February 7, 2025

Addendum No. A
Regarding the contract documents for ARROYO HS BLEACHER REPLACEMENT, DSA No. 04-123142
For the SAN BERNARDINO CITY UNIFIED SCHOOL DISTRICT
LPA Project No.: 3126710

NOTICE TO BIDDERS

**ARROYO VALLEY HIGH SCHOOL
 BLEACHER REPLACEMENT**
 1881 W BASE LINE STREET
 SAN BERNARDINO, CA 92411
 Developed for
 SAN BERNARDINO CITY UNIFIED SCHOOL DISTRICT

**RECONSTRUCTION
 POWER FLOOR PLAN**

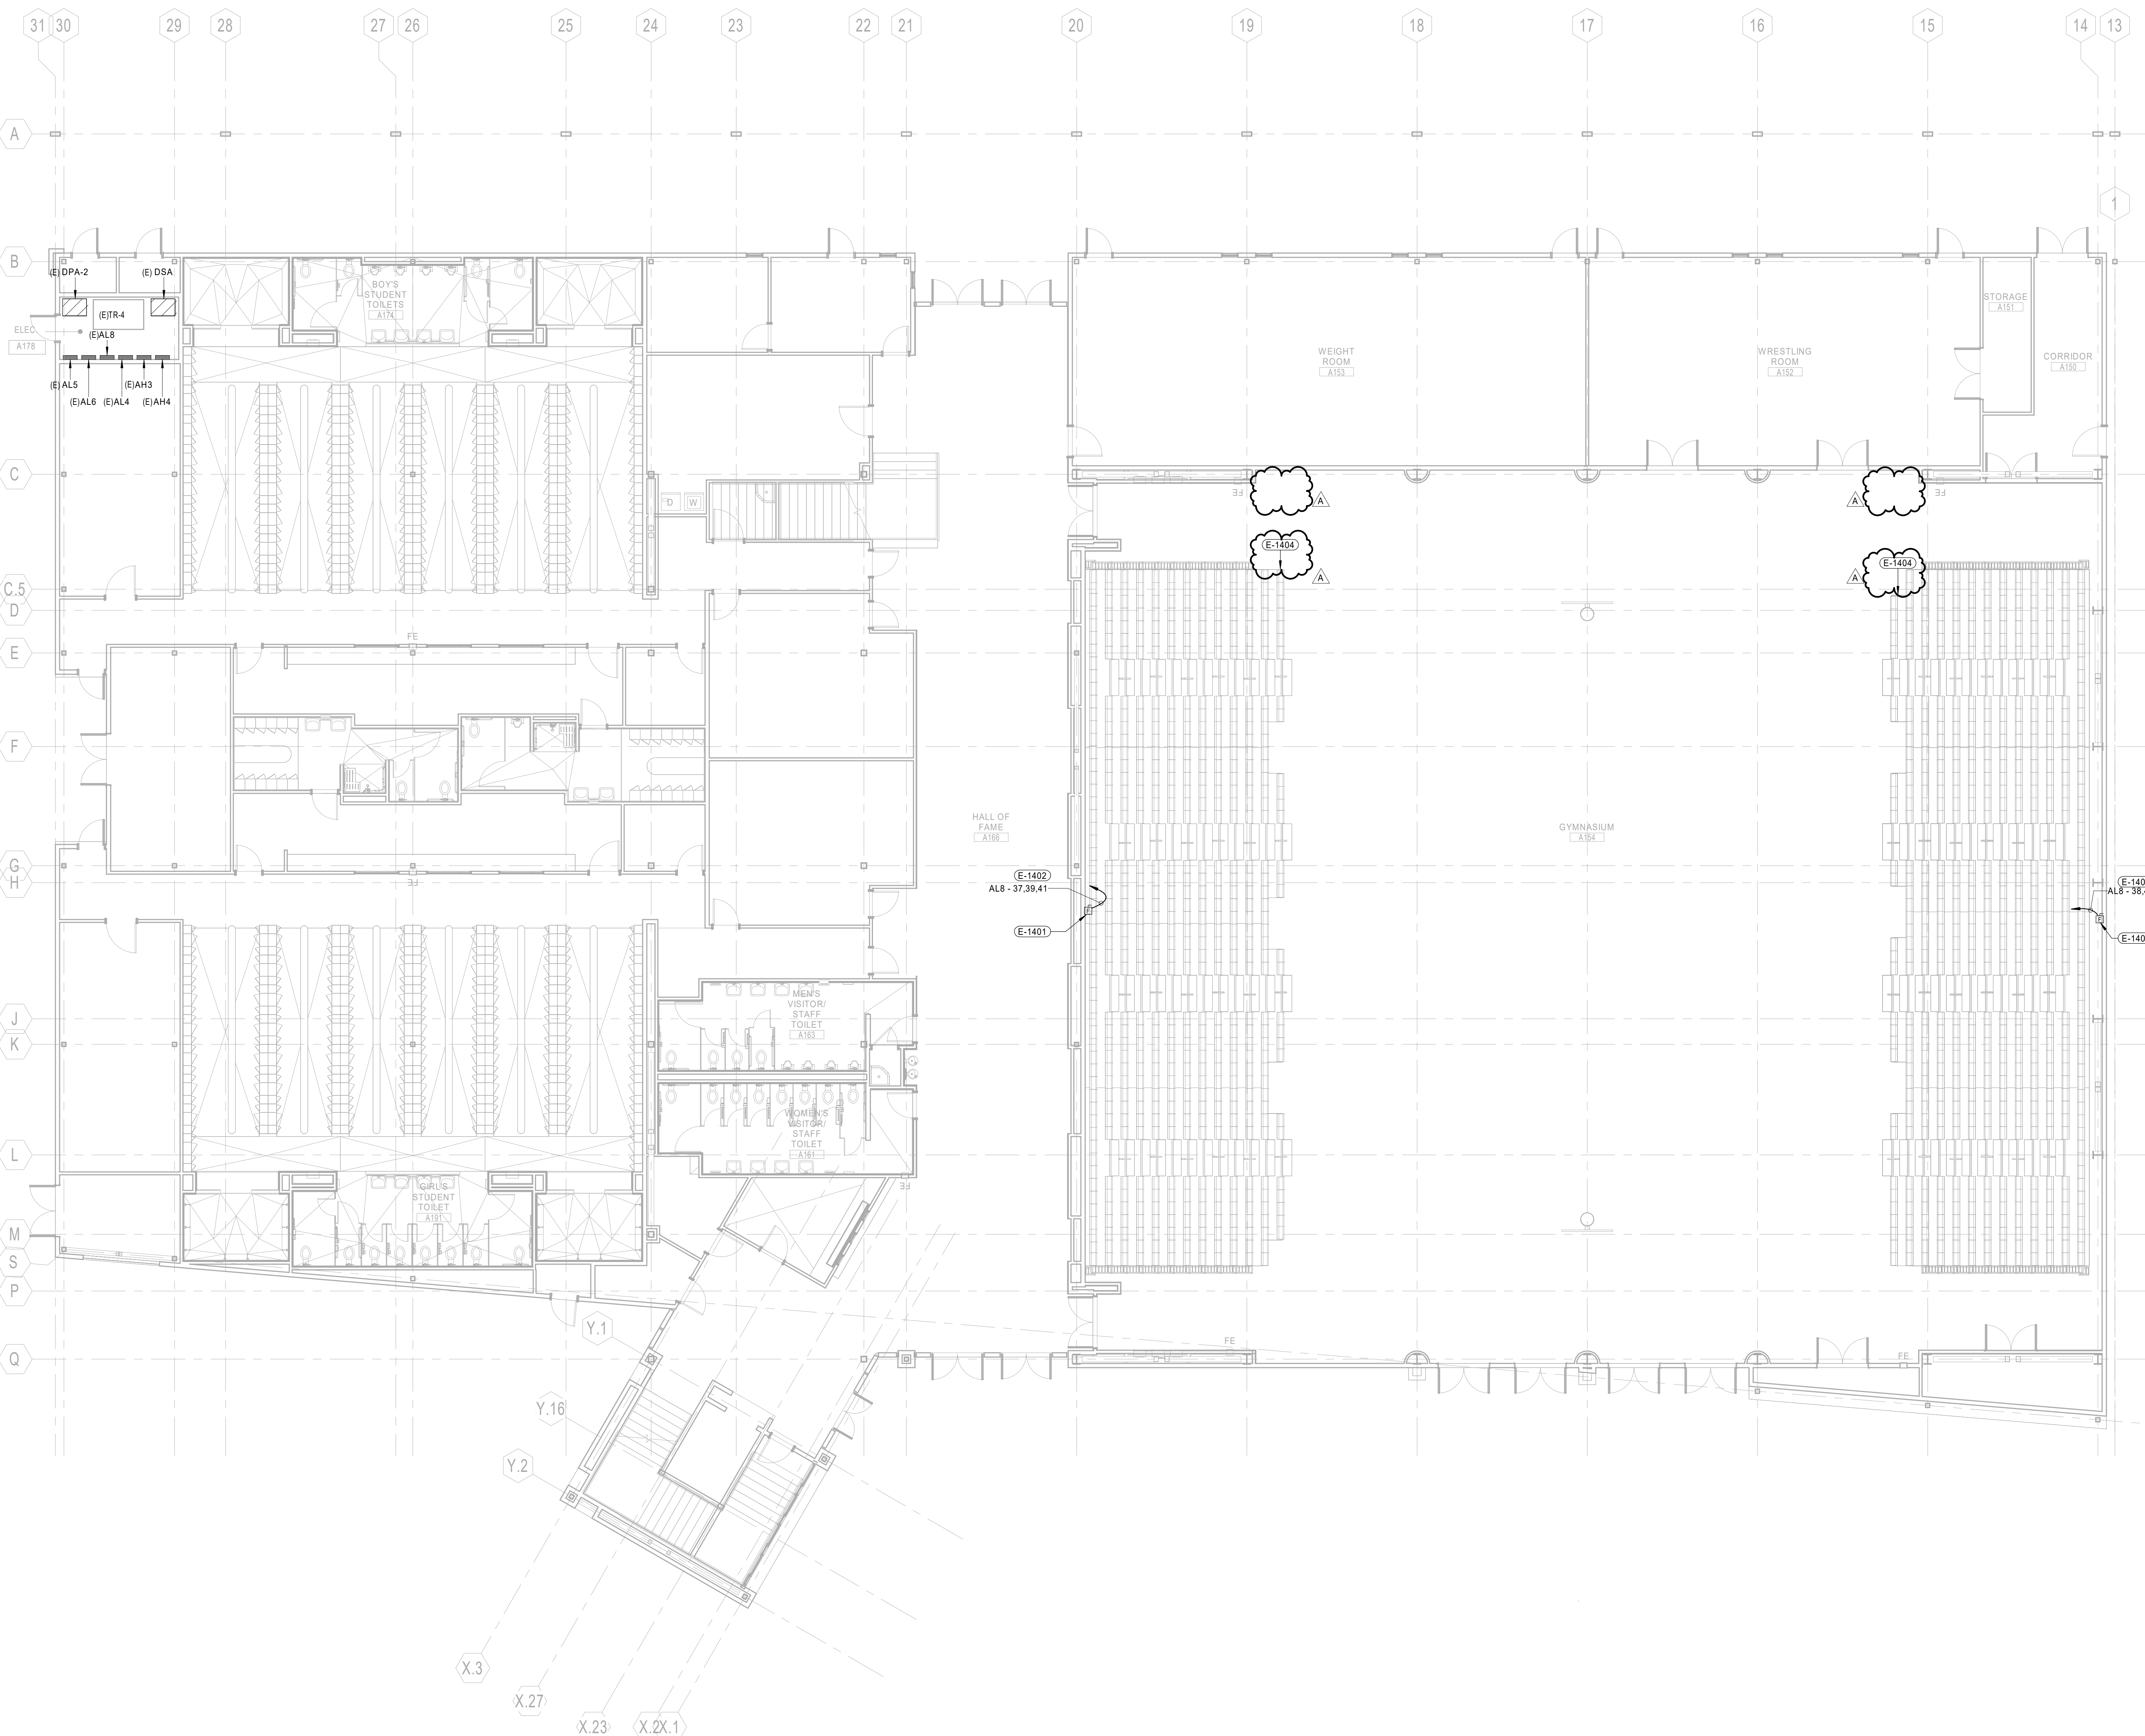
Item No. 1 **Sheet E2.01 – Electrical Reconstruction Power Floor Plan**
a. Updated keynote E-1401 and included the manufacturer and model number.
b. Updated keynote E-1404 and relocated the keynote tags on the plan. The bleacher to be controlled via handheld pendant switch instead of wall mounted switch.

| ITEM | DESCRIPTION |
|--------|--|
| E-1401 | 208V/3PH WALL MOUNTED DISCONNECT SWITCH FOR POWER CONNECTION TO BLEACHERS. MOUNTED AT 48" A.F.F. COORDINATE EXACT LOCATION WITH BLEACHER MANUFACTURER PRIOR TO ROUGH-IN. REFER TO DETAIL 06E7.01 FOR MOUNTING INFORMATION. REFER TO BLEACHER DRAWINGS T1.01 AND T1.02 FOR MORE INFORMATION. WALL MOUNTED DISCONNECT SWITCH (SCHNEIDER, MODEL VHS22N) WEIGHS 8.8LBS OR LESS AND IS NOT SUBJECT TO CSA ANCHORAGE REQUIREMENTS. |
| E-1404 | RETRACTABLE BLEACHERS TO BE CONTROLLED VIA HANDHELD INTERNAL PENDANT SWITCH. HANDHELD INTERNAL PENDANT SWITCH PLUG LOCKS INTO PLACE IN THE FRONT OF THE BLEACHER STACK. USE PER BLEACHER MANUFACTURER'S RECOMMENDATION. |

TYPICAL WALL MOUNTED EQUIPMENT SCHEDULE AND DETAILS 1" = 1'-0" 09

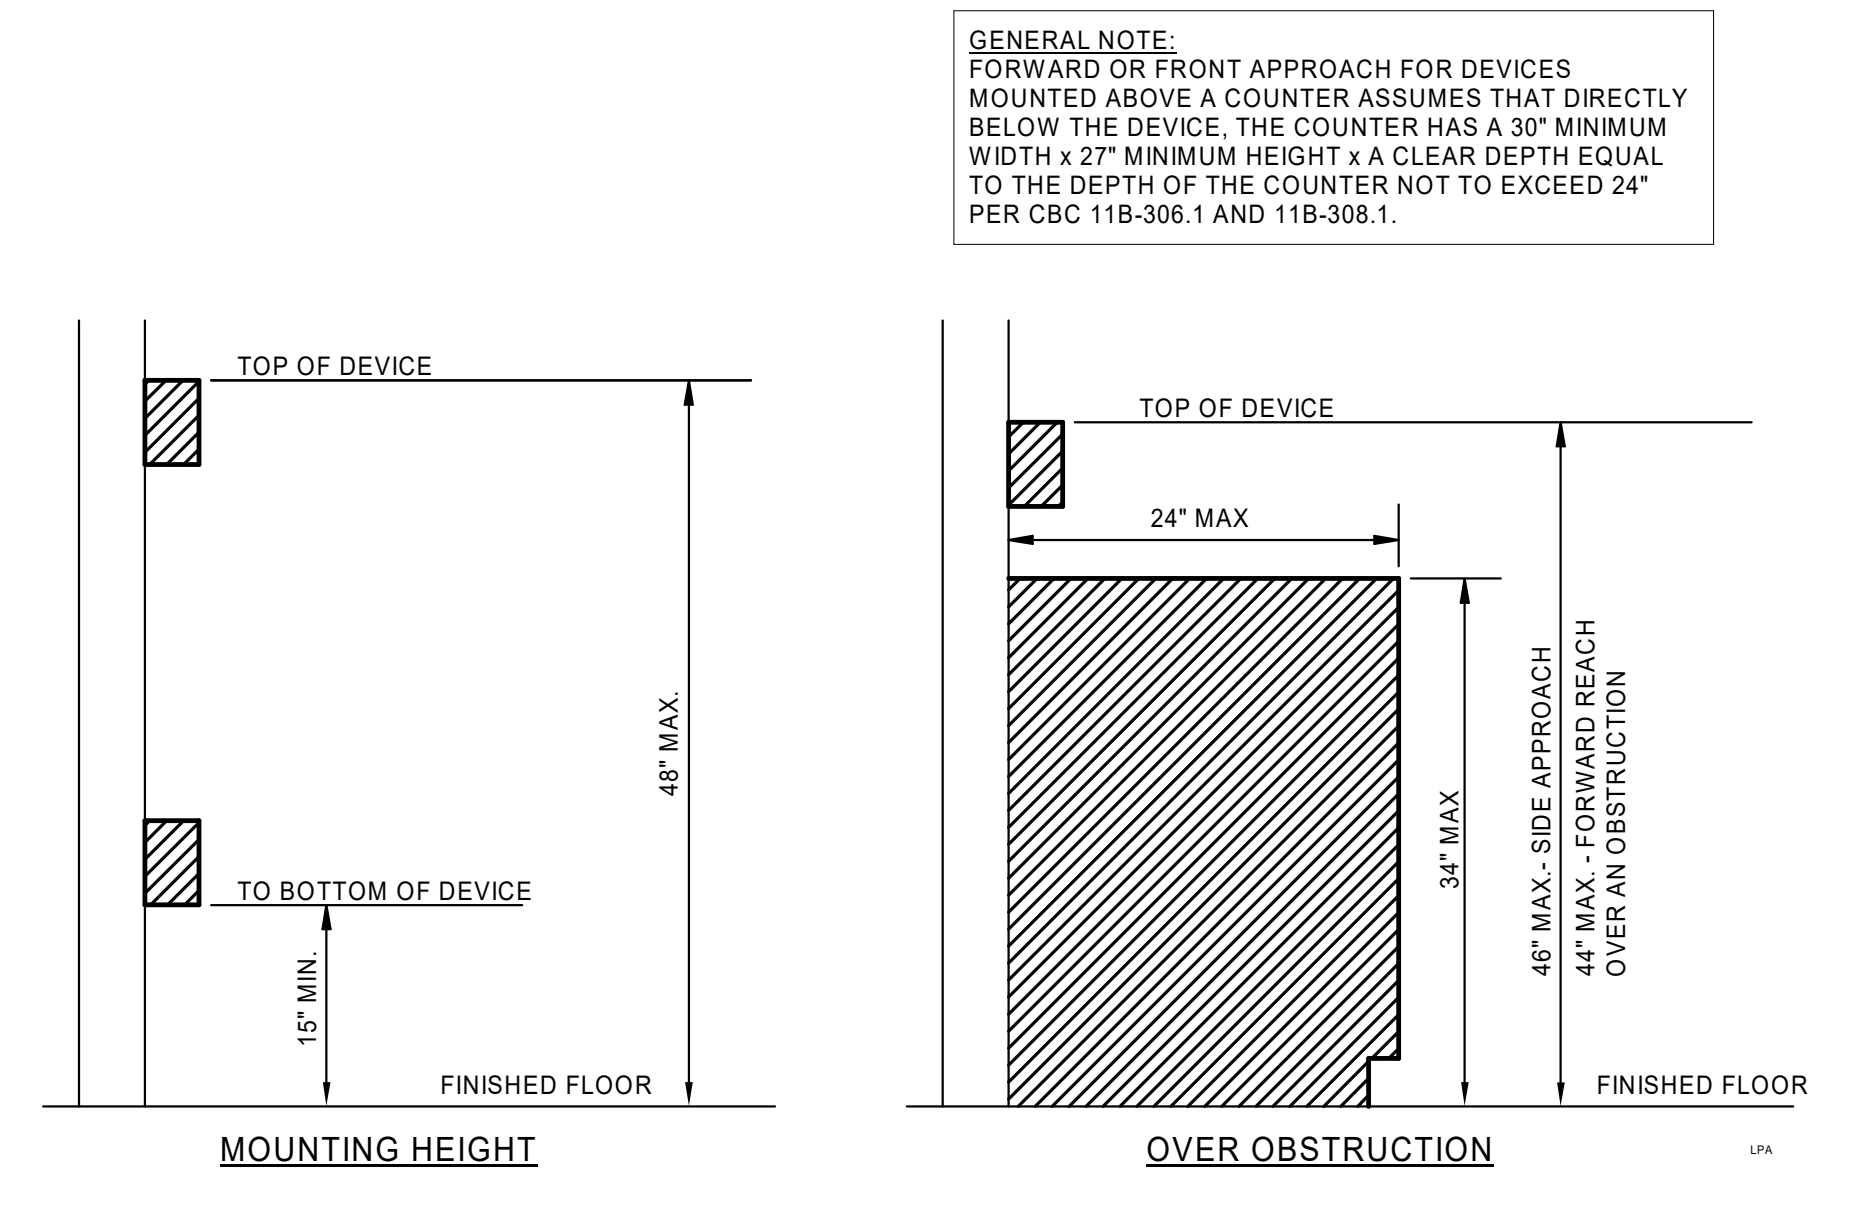
Item No. 2 **Sheet E7.01 – Electrical Details**
a. Updated detail 09, the dimensions and the weight to use smaller safety disconnect switch boxes.

ANCHORAGE SCHEDULE - WALL MOUNTED ELECTRICAL EQUIPMENT

| EQUIPMENT | LOCATION (ROOM NO.) | WEIGHT (lbs) | HEIGHT (ft) | WIDTH (in) | DEPTH (in) | SCREWS - SEE NOTE 1 | |
|-------------------|---------------------|--------------|-------------|------------|------------|---------------------|------------------------|
| DISCONNECT SWITCH | A154 | 8.8 | 14.57 | 6.36 | 5.11 | 2 | 2 |
| DISCONNECT SWITCH | A154 | 8.8 | 14.57 | 6.36 | 5.11 | 2 | 2 |

NOTE:
 1. AT METAL STUDS SCREWS SHALL BE HILTI#12 SELF-DRILLING SCREWS (ICC ESR-2196).
